**Guy Smith Stadium Improvements Phase 2
Addendum No. 02**

Project Name: Guy Smith Stadium Improvements	Project No.: RFP#23-24-19
Prepared By: Mark Nottingham	Date: 10-12-2023

2	Scale	SPECTATOR SAFETY NETTING ELEVATION
	1/16" = 1'-0"

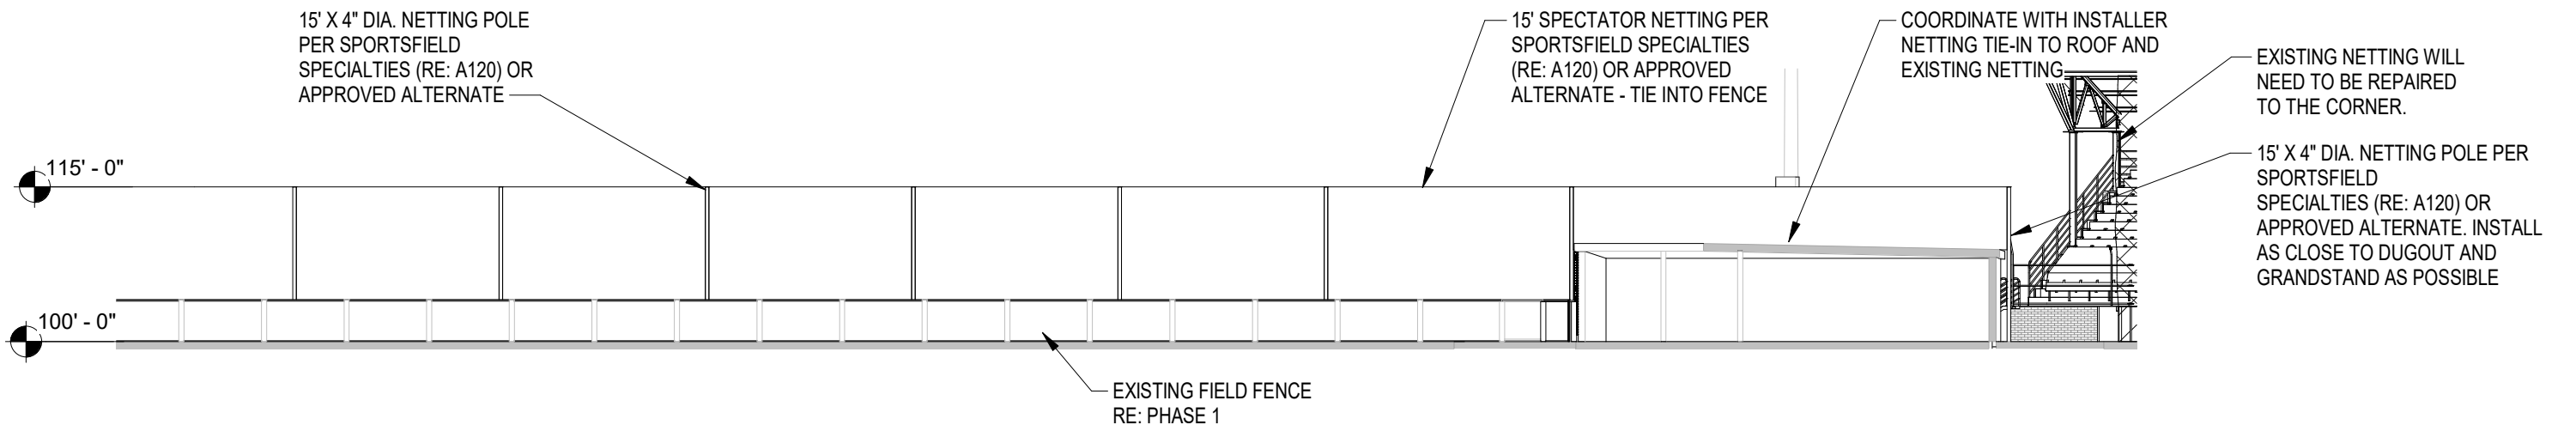
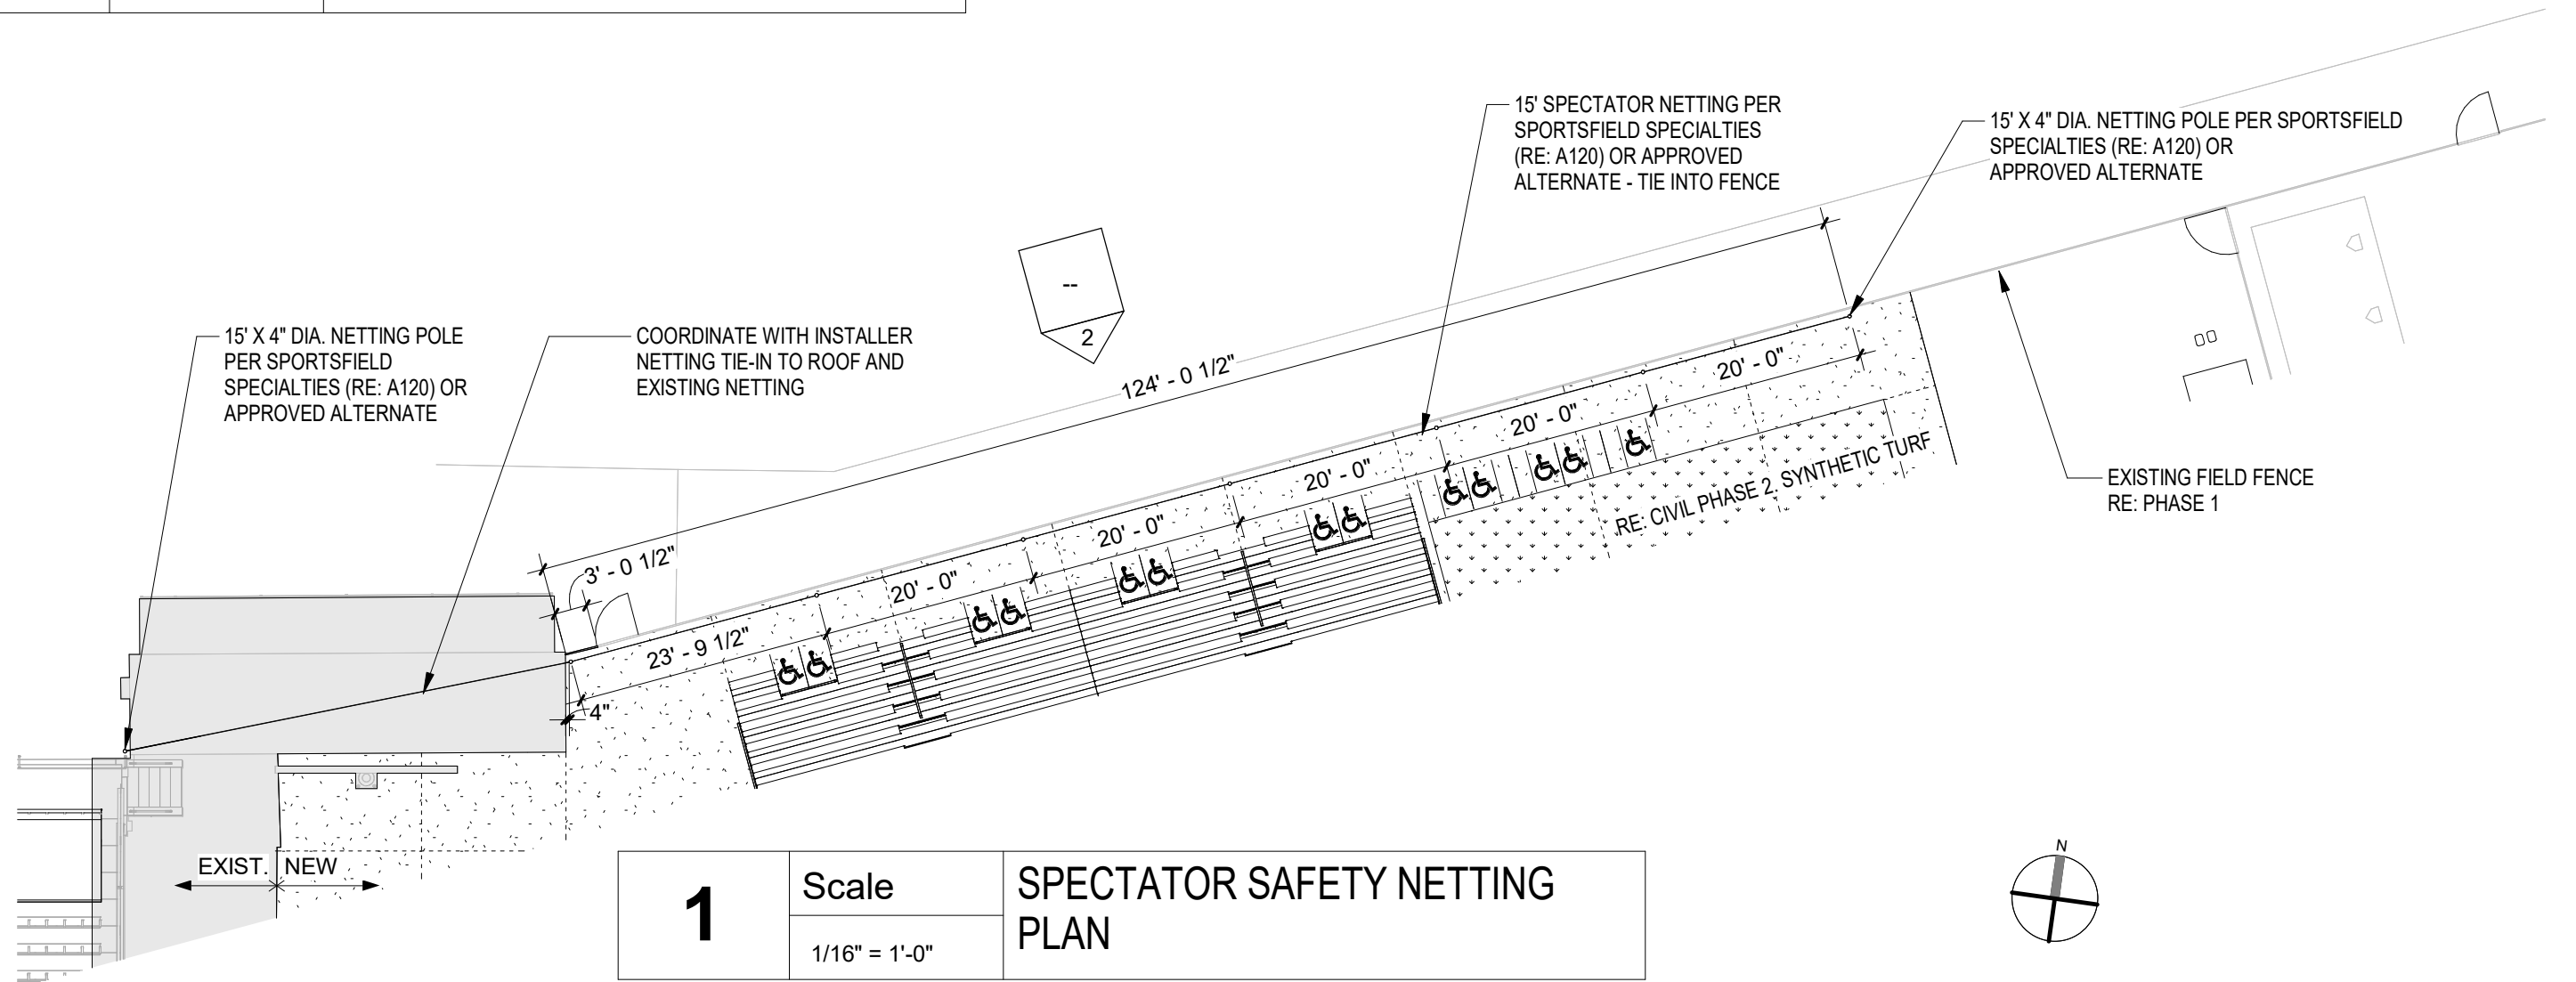
1 - Drawing A111 shows us to install sport netting along the 1st base line. It appears that the intent is to install (2) new poles. Are we to tie-into the existing netting where it stops just short of the dugout? If so, can you confirm that the existing structure can support the new netting? Is there any need to replace the netting along the backstop?

2 - Are there any design parameters around that. Netting? How high does it need to be, does it need to be removable or is fixed acceptable.

See attached sketch and supporting information.
